# Duquesne Light

SUBJECT: Beaver Valley Power Station - Unit No. 2  
Docket No. 50-412  
NRC Structural Design Audit

## NRC STRUCTURAL AUDIT ACTION ITEMS

Figure 7.1  
 Three-Step Soil-Structure  
 Interaction Solution  
 Beaver Valley Power Station  
 Unit 2

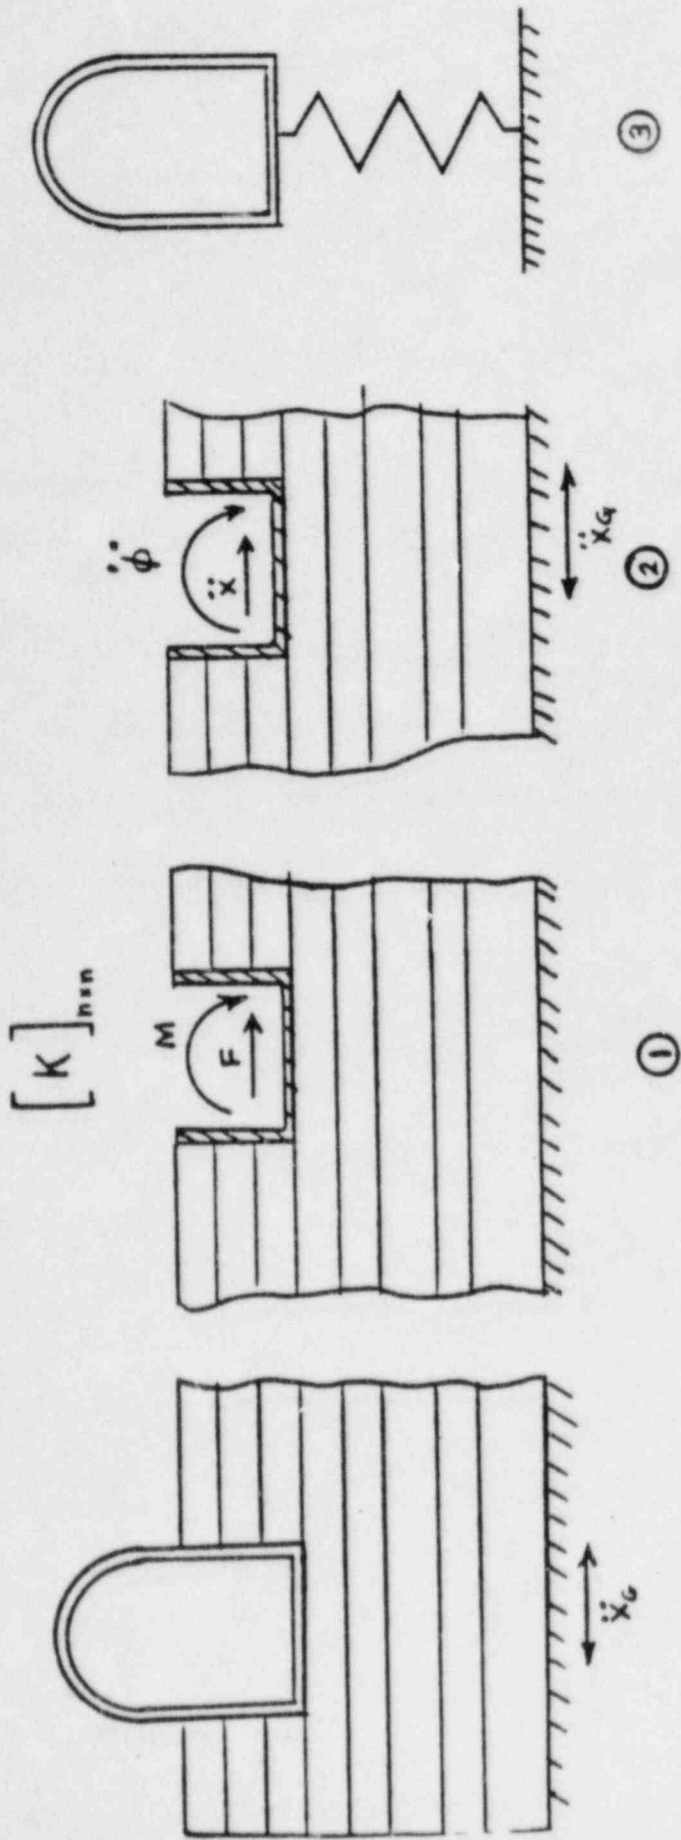
7. Perform soil-structure interaction analyses for the two key structures (containment and intake structure) to show that the intent of SRP 3.7.2.II.4 is met. Where discrepancies from the SRP are identified, provide a justification by accounting for as-built strength of materials and design conservatisms. Also, compute for the intake structure applicable safety factors against sliding and overturning based on the revised analyses and show conformance to the criteria of SRP Section 3.8.5.

To demonstrate that the intent of SRP 3.7.2.II.4 is met, an alternate soil-structure model of the containment was developed. The original soil-structure interaction analysis used the finite element method (PLAXLY computer code), in which the soil was modeled as finite elements and the structure as a lumped mass elastic beam (FSAR Section 3.7.2).

The alternate soil-structure interaction analysis uses the same lumped mass elastic beam model to represent the containment structure; the soil is modeled as a half-space using the compliance function method of analysis. The analysis method is based on the three-step solution developed by Kausel and Whitman.

The three-step method consists of the following:

1. Calculation of frequency-dependent soil stiffness (subgrade impedances)
2. Modification of the specified surface motion to account for structure embedment (kinematic interaction)
3. Interaction analysis

These steps are presented on Figure 7.1.

In the second step of the analysis shown on Figure 7.1, the purely translational input ground motion specified at the surface of the stratum is transformed into both a translational and rotational motion at the base of the rigid, massless foundation. In a stratum undergoing translational motion only, the boundary conditions at the "excavation" require the foundation to rotate.

Figure 10.1

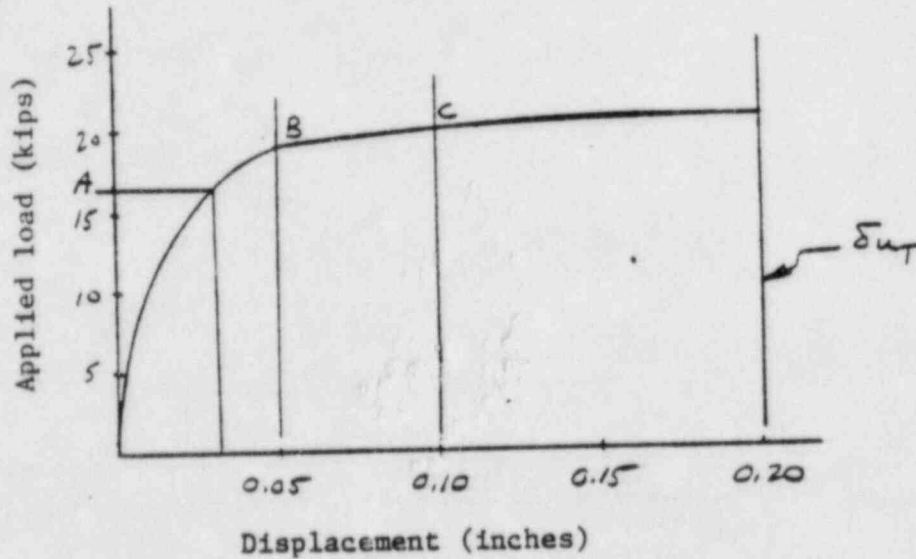
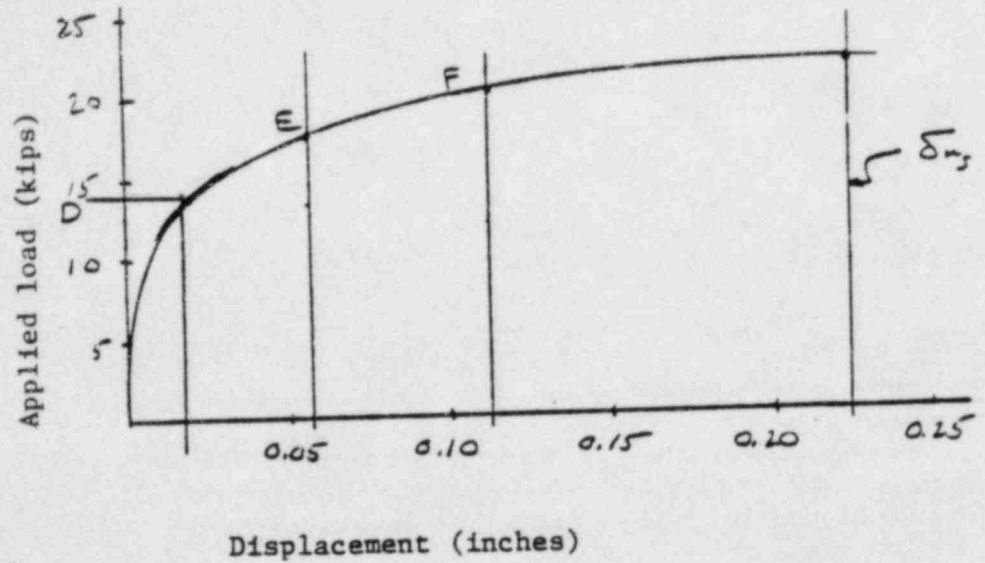
10. Identify the differences between ASME III Division 2 and specific criteria used in design of BVPS-2 liner and justify any deviations therefrom.

CC-3730 (b) The allowable force and  
displacement capacities of liner  
anchors are given in Table CC-3730-1.  
These values are listed in Attach-  
ment 10.3.

BVPS-2 used the tension and shear  
allowable design loads shown in  
Attachment 10.3. The BVPS-2 anchors  
of the general liner are designed  
for the load combinations shown in  
Attachment 10.1. Where anchors have  
mechanical loads, the mechanical  
loads are added to the load combi-  
nations in Attachment 10.1. For  
displacement limited loads, the  
BVPS-2 allowable design loads are  
well below the Division 2 allow-  
ables. For mechanical loads, the

BVPS-2 anchor studs have an  
adequate margin based on worst  
case design loads and ultimate  
displacements.

BVPS-2 allowable design loads are greater than the Division 2 allowables. As shown on Figures 10.1 and 10.2 there is adequate margin between the BVPS-2 allowable design loads and the ultimate failure capacity of the anchor. The BVPS-2 values result in a factor of safety of 3 for tension and 10 for shear when comparing the displacement at the allowable design load to the anchor's ultimate displacement (based on the Nelson Stud).

Figure 19.1  
Typical Cross-Section of  
Buried Conduit Duct Bank  
Beaver Valley Power Station  
Unit 2

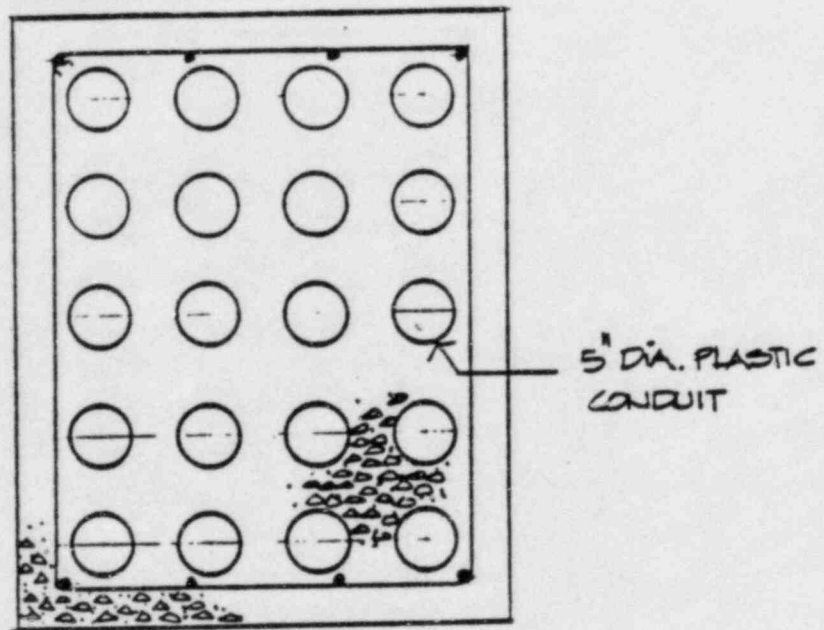
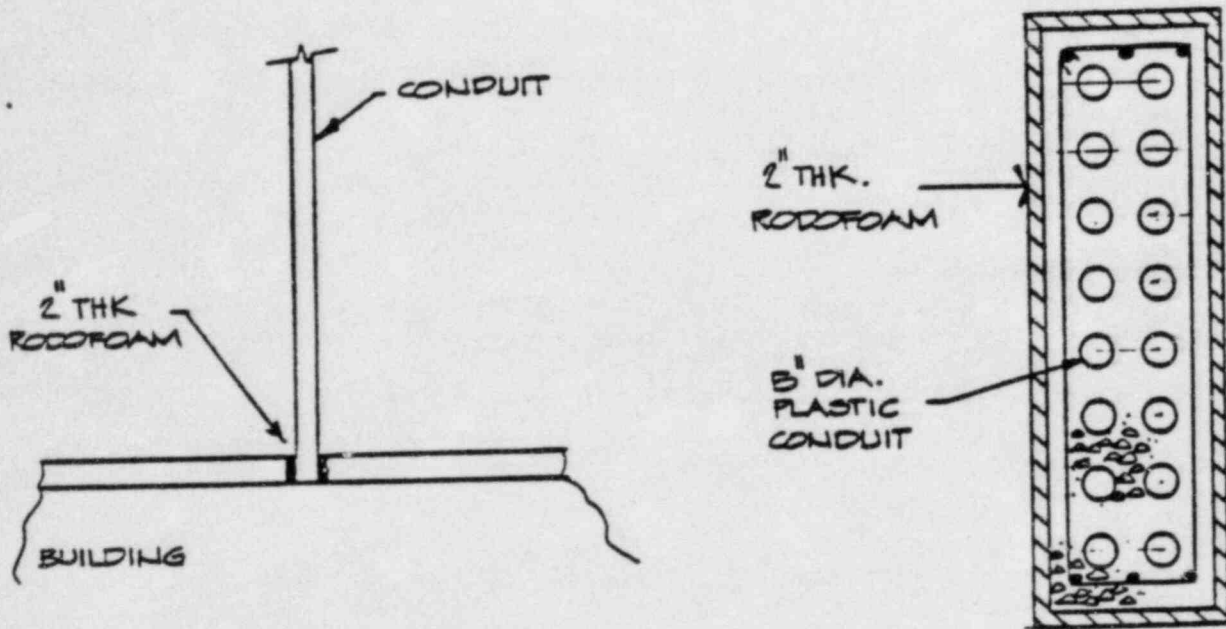
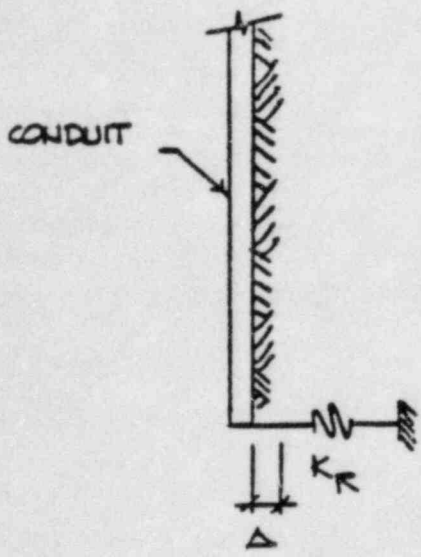
19. With respect to Category I duct banks, describe the design criteria and analysis procedures used to demonstrate the adequacy, and also indicate if the applicable criteria of SRP Section 3.8.4 were met. For any deviations from the criteria identified, please provide a justification considering the as-built material strengths and conservatism, as appropriate.

The design criteria and analysis procedures used to demonstrate the adequacy of the buried seismic Category I conduit duct bank systems at BVPS-2 are in accordance with the Standard Review Plan (SRP) Section 3.8.4 criteria. The analysis considers the following conditions:

Condition (1) was assessed using well-known methodology such as that of Terzaghi (1955). The effect of the soil pressure on the structural integrity of the buried conduits at BVPS-2 is insignificant due to their cross-section configuration. A typical cross-section of a buried conduit duct bank is shown on Figure 19.1. The effect of conditions (2), (3), and (4) were established with an equivalent static analysis which considers the conduit duct bank as a beam element supported on an elastic foundation.

The effect on the buried conduit duct bank produced by differential movements between the structures to which they are attached and the adjacent soil is assessed by considering the conduit as a beam element supported on an elastic foundation. The analysis is based on compatibility of displacements at the point of attachment. The analytical model considers the beam on elastic foundation and the material in the shake space as two different spring elements acting in series. A typical junction detail and the analytical model are shown on Figures 19.2 and 19.3. The forces on each of the springs is obtained using the maximum relative displacement corresponding to settlement or seismic motion of the structure. The shear and bending forces along the buried conduit are then computed treating the conduit as a beam on elastic foundation with a concentrated load acting at the point of attachment.

Figure 20.1  
 Standard Cable Tray Support Types  
 Beaver Valley Power Station -  
 Unit 2

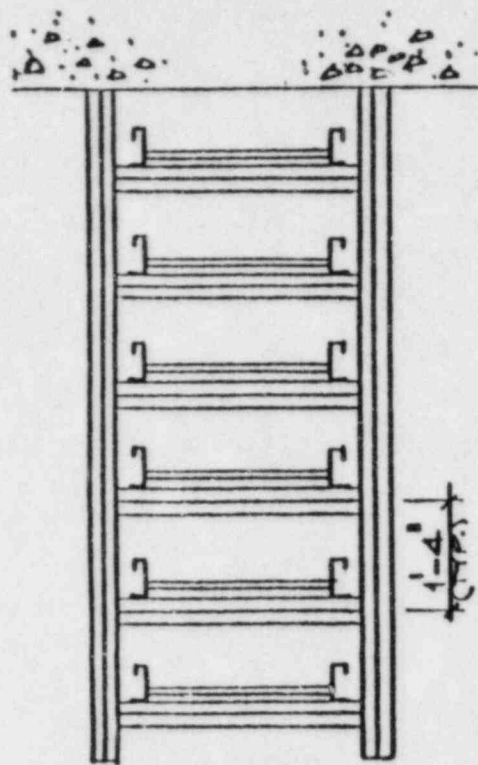
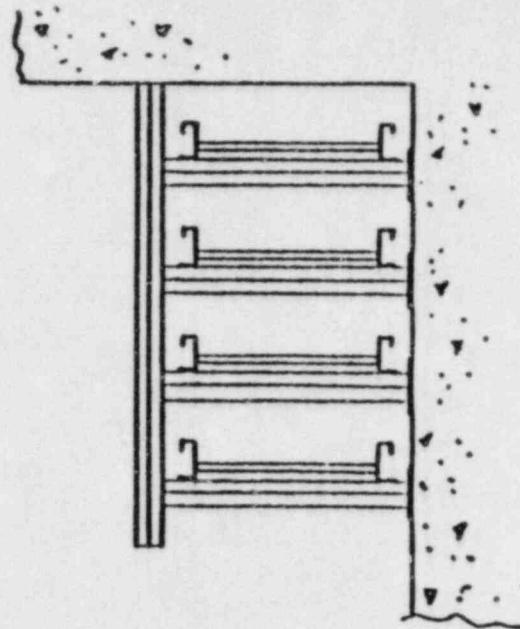
20. Describe the key types of cable tray (and conduit) configurations used at BVPS-2. For each of the configurations identified, evaluate if the criteria provided in SRP Section 3.8.4 were fully met in the design and analysis of the trays (and conduit). For any deviations from the criteria identified, please provide a justification considering the as-built material strength and conservatism, as appropriate. The selection of key types of cable trays should consider the various layers of decking as well as the variability in supports and anchoring effects.

The cable tray supports at BVPS-2 are of three basic types: trapeze, propped cantilever, and cantilever. An illustration of each type of support is shown on Figure 20.1. The standard vertical spacing between cable trays is 1'-4".
